**ADDENDUM NO. 2**  
**February 10, 2025**

**DLH North Business Development Area Hangar**  
**City Project No. 25-4401**  
**Duluth International Airprt**  
**Duluth, Minnesota**

**SEH No. DULAI 180746**

PEMB FLOOR PLAN - LEVEL 1 & DOOR SCHEDULE

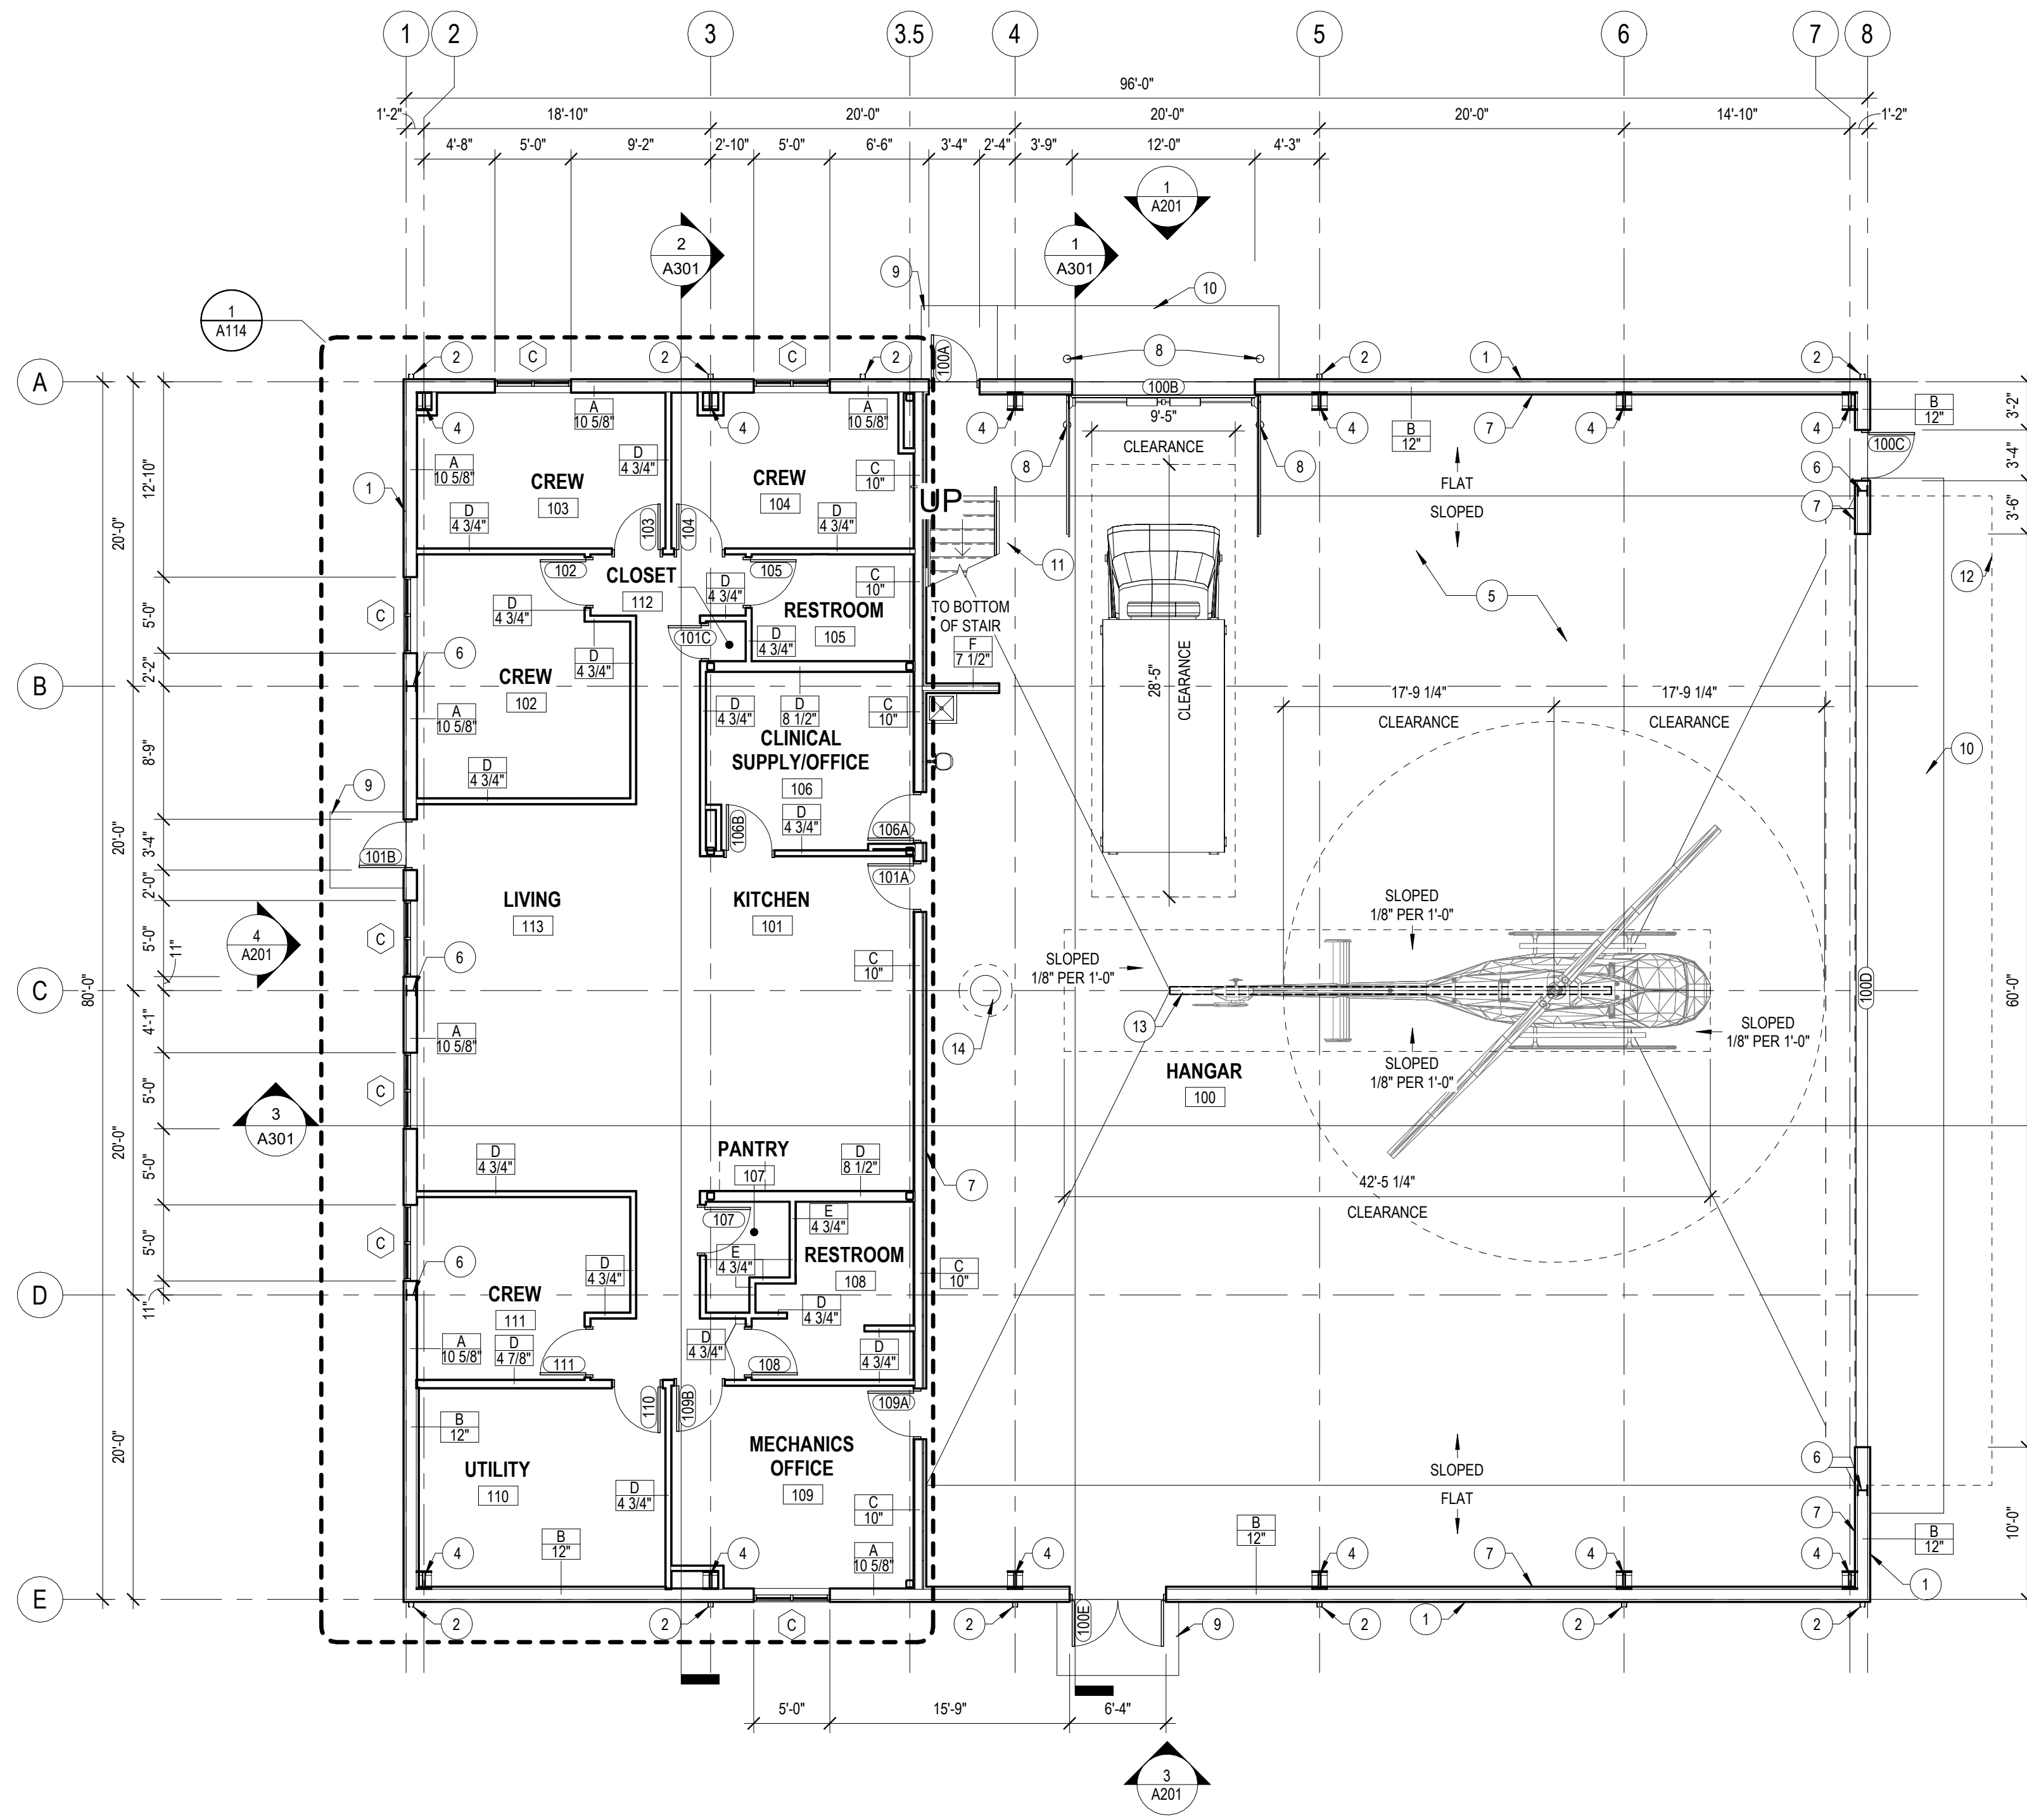
6. Q: I need clarification on the bi-fold door size. Is it 60x16 clear open when the door is open? According to the drawing the architect is showing the top of the door at 16' which would make the bi-fold 13' 6" when open. Please clarify.

*A: See updated attached Architectural sheets. This bi-fold door clearance will need to be 16'.*

DOOR REMARKS  
A. PAINT DOOR AND FRAME  
B. INSULATE DOOR/FRAME  
C. POWERED OPERATION  
D. CLEAR OPENING TO BE 16"  
E. REMOVABLE CENTER MULLION  
F. NO CLOSER  
G. SEE THRESHOLD DETAIL 7/A400
